Development Application DA2020/0061 - 59 Cutler Road CLONTARF NSW 2093

61 Cutler Road response to 59 Cutler Road DA Development Application DA2020/0061

Table1. – Wall heights

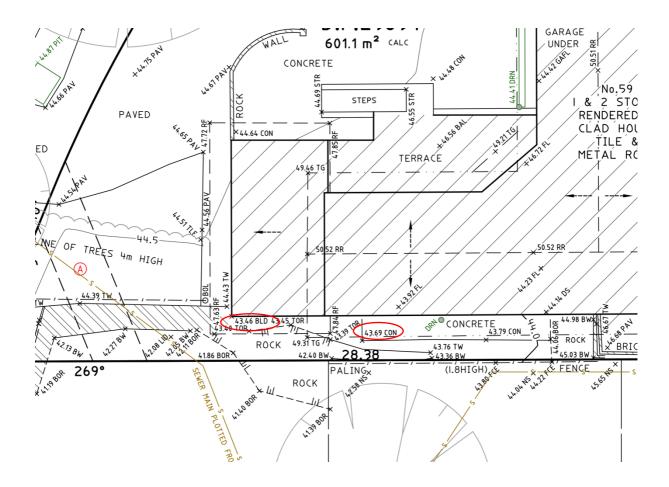
GF	1F	2F
Ground RL	43.46	43.46	43.69
Proposed roof RL	47.072	50.295	53.205
Proposed Wall height	3.612m	6.835m	9.515m

The proposal increases the non-compliance with the Height of Building development standard. As a result, the southern elevation of the proposal has an overall height of 9.515 metres, providing a non compliance of metres, in excess of 8.5m limit.

The representation of 8.5metre height limit shows the non-compliance for the majority of Level 3 of the proposal on southern boundary accentuated over W22,23 where the amenity impact and bulk and scale overbearing is greater to 61 Cutler Road due to the topographical level difference with the retaining wall.

Through better design this impact could be reduced by relocating the bedroom and balcony to the void area.

This is a photo attached in the assessment report of DA REV2018/0018 for 61 Cutler Road.

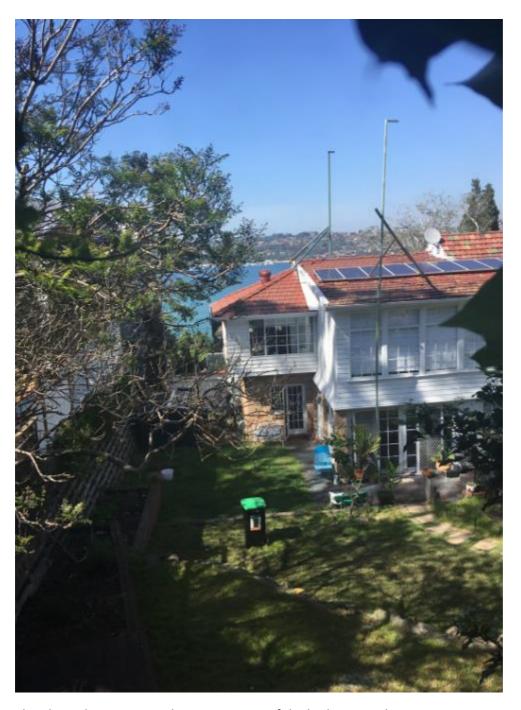
This photo was taken from 59 Cutler Road Clontarf.

The photo demonstrates the 1F extension of the bedroom and ensuite, 2F extension results a detrimental impact on 61 Cutler in regards to visual and acoustic privacy.

Table 3. Retaining wall height

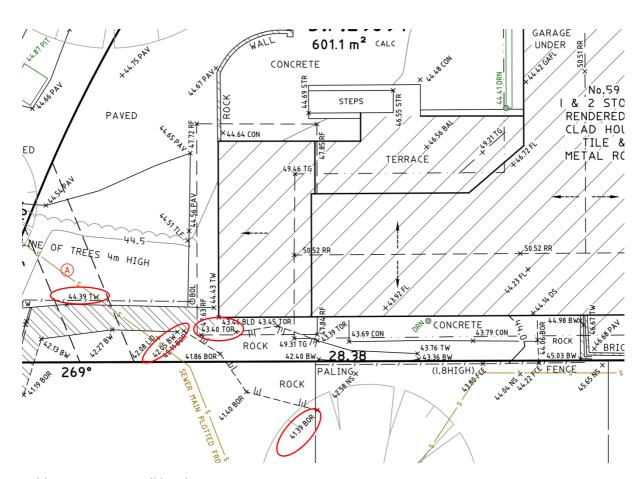
Top of the wall/ rock	44.39/ 43.4
Bottom of the wall (retaining wall) at the side boundary between 59 and 61 Cutler Road.	42.05-42.4
Wall height within 59 Cutler	2.34m / 1.35m
Bottom of the wall in 61 Cutler Road.	41.39
Wall height viewed from 61 Cutler Road	3m/ 2.01m

The property is built on top of the retaining wall within the property, adding to the overall height of the development when viewed from 61 Cutler Road and adding to the overlooking issue.

This is exacerbated with 19 extensive glazing, causing unacceptable privacy impact to 61 Cutler Road, looking directly into living room, kitchen, 3 bedrooms and dress room and all open space area including laundry hanging area.
